OUTBOARD MARINE CORPORATION SUPERFUND SITE

Value Engineering Study For U.S. Environmental Protection Agency

Final Report
December 14, 2007

Figure 1: Cost savings compared to lift thickness and compaction effort

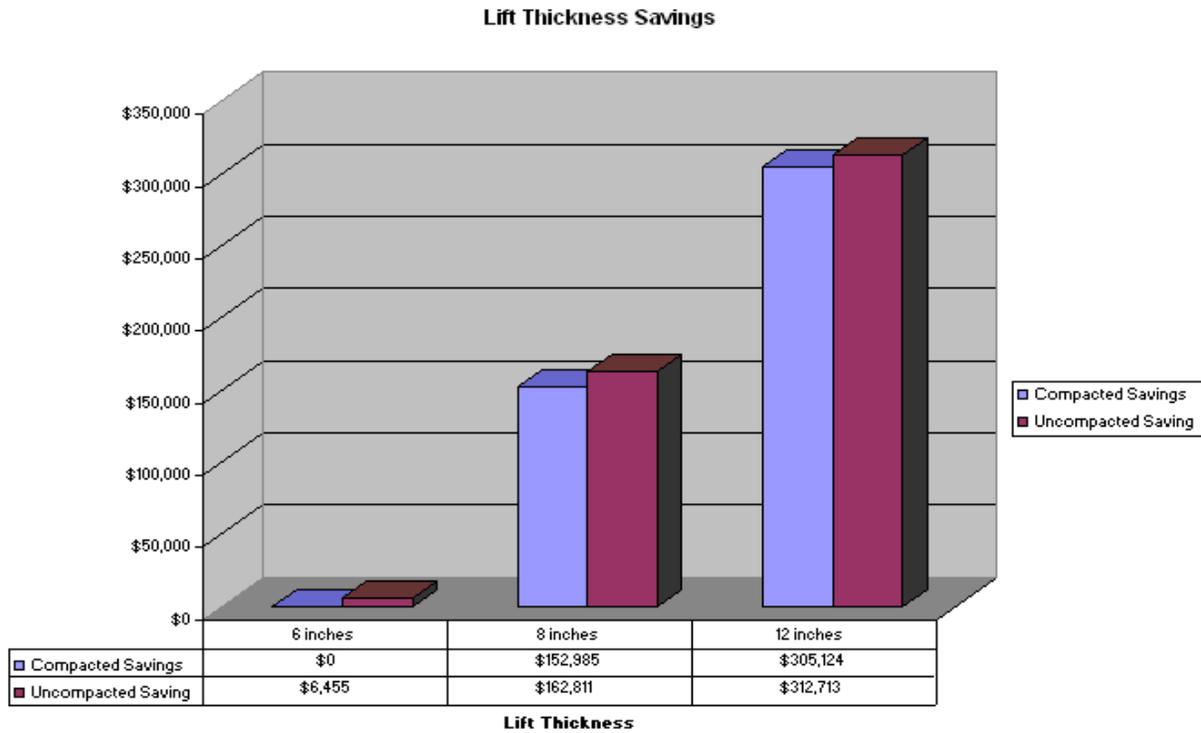
Acceptance of this value engineering recommendation will result in a reduction as demonstrated chart (Figure #1) below. It should be further noted that the Designer of Record's estimate included an additional 21,000 CY of contaminated soil to be excavated once the building's concrete slab is removed and the soil can be characterized. However, the estimate did not include importing soil and backfilling this area. Therefore, this area was not included in this Value Engineering Recommendation. If this value engineering recommendation is accepted to include the excavation areas within the building limits, additional savings will be realized.

SKETCH OF ORIGINAL DESIGN

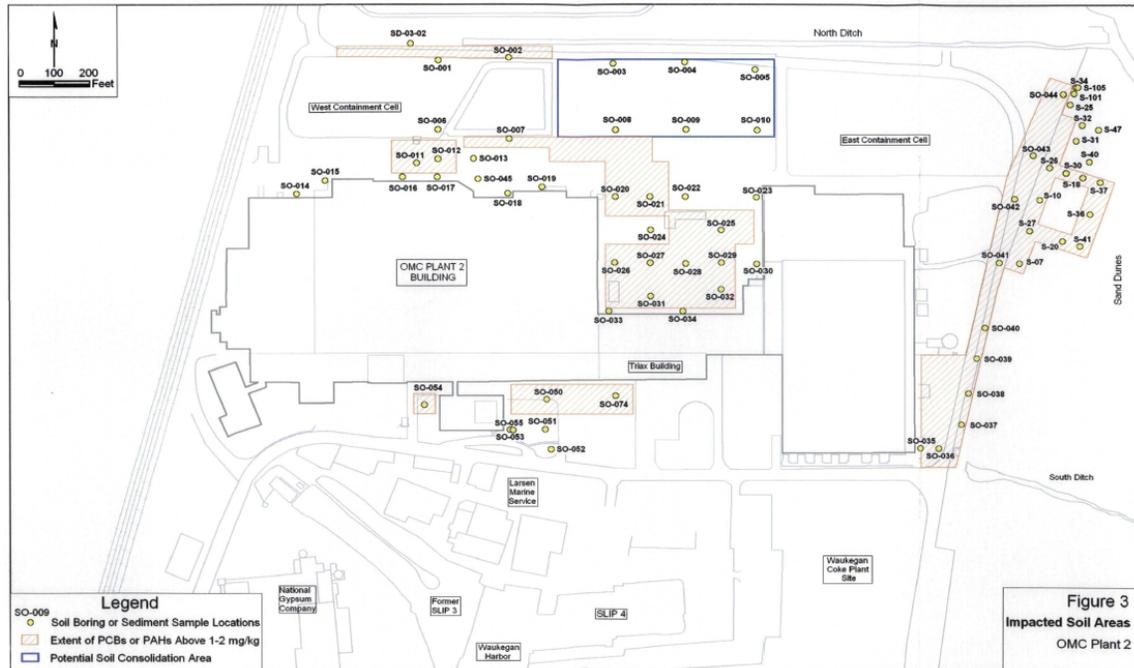
0'-2' PCB & SVOC Excavation to be backfilled in compacted 6" lifts: 27,500 CY or 41,200 SY
